**ENVIRONMENTAL BOARD REGULAR MEETING MINUTES WEDNESDAY,
September 20, 2008.**

SUBJECT: Wildflower Commons PUD - C814-06-0233
4700 – 5200 Blocks of State Highway 45

SUBJECT: Corrections to ERM's August 22, 2007 memo regarding Critical Environmental Feature setbacks of Wildflower Commons.

SUBJECT: Bulldog Storage SP-2007-0673D

Map 1: Location Map for Critical Environmental Feature Setbacks
(Revised - 07-07-2008)

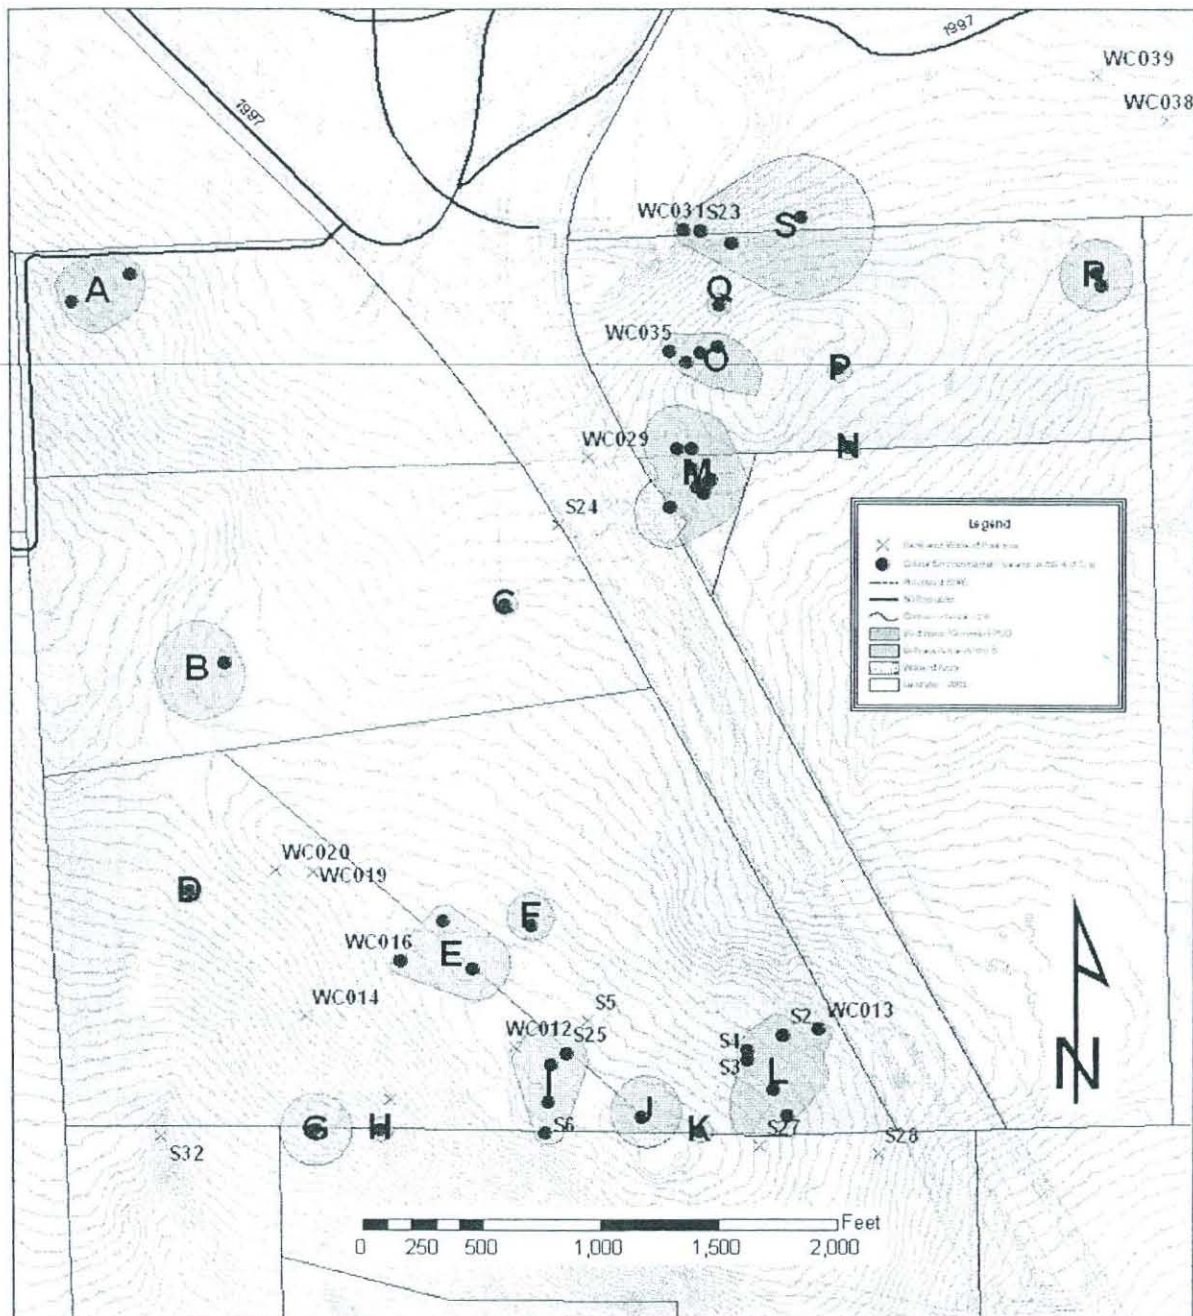
Based the surface drainage patterns, 2-ft topography, the type of feature, the feature's size and the density (or clustering) of features, ERM staff is recommending protecting the critical environmental features with 19 critical environmental feature setback areas (Labeled A thru S). The attached map shows the location of the setback areas. ERM staff is recommending that the CEFs and their associated setback area (or buffers) are documented within the PUD ordinance along with the following Land Development Code (LDC) requirements from Section 25-8-281.

1. No residential lots may include a CEF or be located within 50 feet of a CEF.
2. Setback areas must be established to protect all CEFs. Although the LDC allows a portion of the CEF buffer to be included in a residential lot, I do not recommend that this be allowed. Residential lots should not include any portion of a CEF buffer. Setbacks must comply with the setback area has stated in Table 1 and shown Map 1. ERM is willing to revise setback areas listed in Table 1 and shown on Map 1 during PUD process, if the applicant provides more detail

information to ERM staff such as 1-ft topographic survey that better delineates the catchment areas and a hydrogeologic assessment the features that better evaluates its recharge potential.

3. No disturbance of native vegetation is allowed within the buffer zone. This shall be stated in a section of the PUD ordinance specifically addressing Critical Environmental Feature protection.
4. No construction is allowed within the buffer zone, except for cave gates and educational trails built in compliance with 25-8-281 of the LDC. In the PUD ordinance, this shall be stated as "No construction or placement of structures within a Critical Environmental Feature buffer zone."
5. Stormwater disposal or irrigation is prohibited within a CEF buffer zone and shall be stated in the PUD ordinance.
6. Erosion and sedimentation controls must be installed at the perimeter of all CEF buffers prior to the initiation of construction.
